# Access Compliance Report

## Public Rights-of-Way

Intersection ID: 2813	Main Street: RIDGEFIELD_DR	Cross Street: SWANSTON_DR	Location: NW
ADA ID: B746E304D3FB	Ramp Type: PerpDiag	Initial Pass/Fail: Fail	Overall Compliance: No
Severity Score: 22.5			
Codes/Mitigation Info/Possible Solution		Field Measurements/Component Compliance

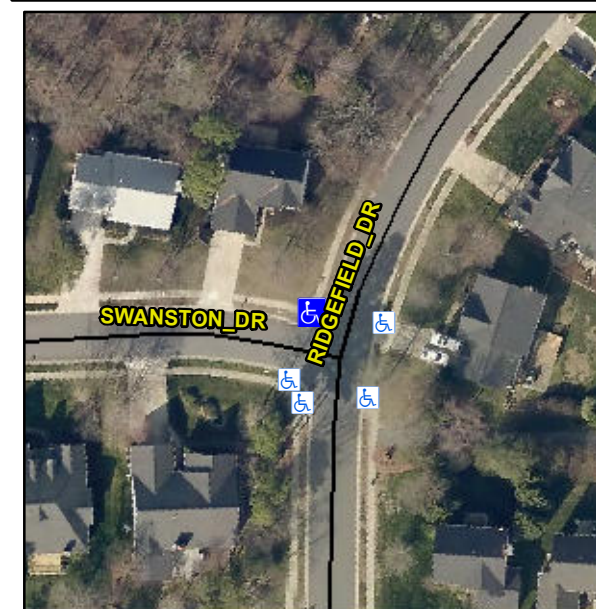
**Not Found, R304.5.1, R304.2.2, R304.5.3**

Compliance	Description	Data	Compliance	Description	Data
N/A	Ramp Length (in)	49.0	No	Ramp Slope (%)	8.7
No	Ramp Width (in)	40.0	No	Ramp XSlope (%)	4.1
N/A	Flare Type LT	N/A	N/A	Flare Type RT	N/A
N/A	Flare Slope LT (%)	N/A	N/A	Flare Slope RT (%)	N/A
N/A	Flare Traversable LT?	N/A	N/A	Flare Traversable RT?	N/A
N/A	Landing Length (in)	N/A	N/A	DWS Provided?	N/A
N/A	Landing Width (in)	N/A	N/A	DWS Contrast?	N/A
N/A	Landing Slope (%)	N/A	N/A	DWS Length (in)	N/A
N/A	Landing X Slope (%)	N/A	N/A	DWS Full Width?	N/A
N/A	Landing Curb? (Y/N)	N/A	N/A	DWS Offset (in)	N/A
N/A	Shared Landing?	N/A			
N/A	Gutter Ponding?	N/A	N/A	Gutter Slope (%)	N/A
N/A	Gutter Lip Ht (in)	N/A	N/A	Gutter X Slope (%)	N/A
N/A	Painted X Walk1?	No	N/A	Painted X Walk2?	No
	X Walk 1 Direction	To S		X Walk 2 Direction	To E
N/A	X Walk 1 Width (in)	N/A	N/A	X Walk 2 Width (in)	N/A
	X Walk 1 Slope (%)	1.2		X Walk 2 Slope (%)	5.6
	X Walk 1 X Slope (%)	5.1		X Walk 2 X Slope (%)	2.5

**Remove & Replace Curb Ramp With Two New Directional Ramps or Equivalent.**
